### Comments on Written Representations – Deadline 3 Submissions

### Deadline 3 Submission - 6.2 Environmental Statement Appendix 13C: Framework Construction Traffic Management Plan and Travel Plan (Tracked) - Rev 02

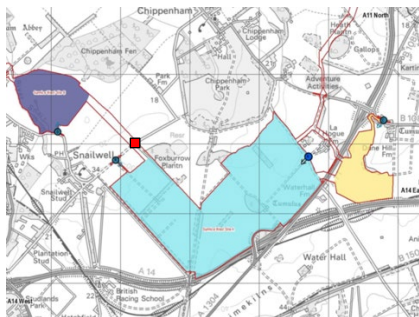
Sunnica states West Site access points B on Chippenham Road and D on Fordham Road are ‘existing access routes’ – they are actually rarely used field (primarily pedestrian) entrances. A further access point is omitted (see red square on image below). This access will also be used within construction, operational and decommissioning phases. Although shown as a relatively straight line on the map, it is actually a blind bend when approaching from Chippenham. This is not an existing access; it is a field verge without hedging.
